VIRGIN TOWN, UTAH

PLANNING COMMISSION STAFF REPORT

TO:	Virgin Town Planning Commission
FROM:	Ryker Steglich, Town Planner, Sunrise Engineering
DATE:	June 23, 2026 (Revised)
SUBJECT:	Sign Permit Application — The Riv at Zion Monument Sign, 239 W SR-9
MEETING:	Regular Planning Commission Meeting

BACKLIT SIGN CABINET WITH PUSH THRU ACRYLIC LETTERS
SECTION DETAIL - ILLUMINATED WITH
12 VOLT LED MODULES WITH
REMOTE MOUNT TRANSFORMER

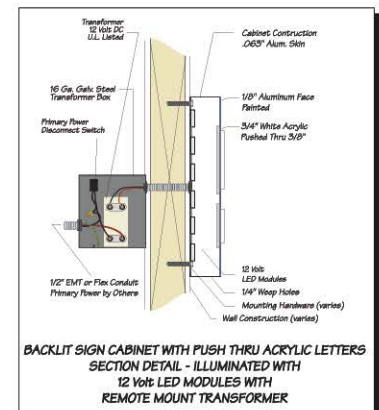
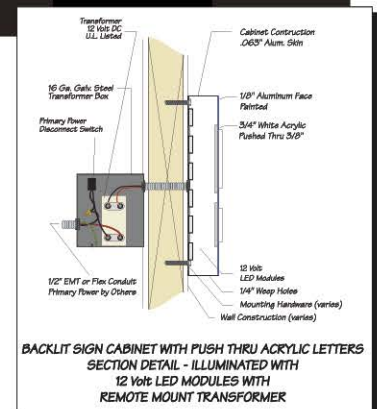
The proposed sign is a double-sided backlit cabinet sign, 84 inches wide by 48 inches tall, mounted on an existing monument rock structure with a 36-inch rock base, for a total sign height of 6 feet as shown on the submitted plans. The primary sign text — “The Riv at Zion” — consists of one-inch white acrylic push-thru letters with painted faces, illuminated from within the cabinet by 12-volt LED modules at 3,000K color temperature. The address line “239 W SR-9 Virgin, UT” is non-illuminated, painted directly on the metal cabinet face. The sign contractor’s night view rendering depicts the letter faces emitting a warm, diffuse glow against the dark cabinet background.

The term “backlit” is not defined in VMC §16-2.12 or anywhere else in the VMC. Applying its ordinary and trade meaning, a backlit sign is one whose face is not illuminated from the front — that is, a sign illuminated from behind or within rather than by a light source directed at the front of the sign face. The proposed sign, in which concealed LED modules illuminate push-thru acrylic letters from within the cabinet, is a backlit sign under this ordinary meaning. The specific type and placement of the concealed illumination is not determinative; what matters is that the illumination does not originate from the front (face) side of the sign. The proposed sign qualifies as a backlit sign and is permitted under VMC §50.10(F).

- The fully-shielded fixture standard is directed at luminaires — lamps within housings that illuminate surfaces or areas and can be shielded and aimed downward. A backlit sign is not such a luminaire; the sign face is itself the illuminated element. The push-thru acrylic cabinet face necessarily emits illumination toward viewers, and the horizontal-plane shielding standard has no coherent application to it.

- **Standard (a) — Light source not visible:** The LED modules are enclosed within the cabinet and not directly visible to the viewer. The standard is met.
- **Standard (b) — No harsh, direct illumination:** The illumination is warm (3,000K), low-output (12V LED modules), and diffused through white acrylic push-thru letter faces. The ordinance's reference to a halo effect is illustrative only and does not limit the range of compliant backlit sign types. The night view rendering shows a warm, restrained glow — not harsh or direct illumination. The standard is met.
- **Standard (c) — Low lumen light sources:** 12V LED modules are low-output light sources. Actual lumen output has not been provided in the application materials and should be confirmed as a condition of approval.

Under VMC §52.8.1(A), a freestanding monument sign in commercial and resort zones shall not exceed 40 square feet in area nor 6 feet in height. The proposed sign face measures 84 inches wide by 48 inches tall, equaling 28 square feet — within the 40 square foot maximum. The plans show a sign height of 6 feet, meeting the height maximum precisely. The pre-existing rock monument base is a property structure on which the sign is mounted and is not counted as part of the sign height. Both dimensional standards are met.

- **Color temperature (§50.10(F)(3)):** The proposed 3,000K color temperature meets the 3,000K maximum. The standard is met.
- **Luminance level (§50.10(F)(4)):** The ordinance establishes a maximum luminance of 100 nits (100 candelas per square meter). The application does not include a luminance certification. This should be confirmed as a condition of approval.
- **Sign illumination curfew (§50.10(F)(5)):** Sign illumination must be turned off one hour after sunset or close of business, whichever is later, and remain off until one hour prior to sunrise. Compliance should be required as a condition of approval.

- Prior to permit issuance, the applicant shall provide manufacturer's documentation confirming the total lumen output of the LED modules used in the sign cabinet.

- Prior to permit issuance, the applicant shall provide a manufacturer's luminance specification or third-party certification confirming the sign face luminance does not exceed 100 nits (100 candelas per square meter), as required by VMC §50.10(F)(4).

- The sign illumination shall be controlled by an automatic timer or smart controller programmed to turn off illumination no later than one hour after sunset or close of business, whichever is later, and to remain off until no earlier than one hour prior to sunrise, in conformance with VMC §50.10(F)(5). Evidence of timer installation shall be provided prior to final inspection.
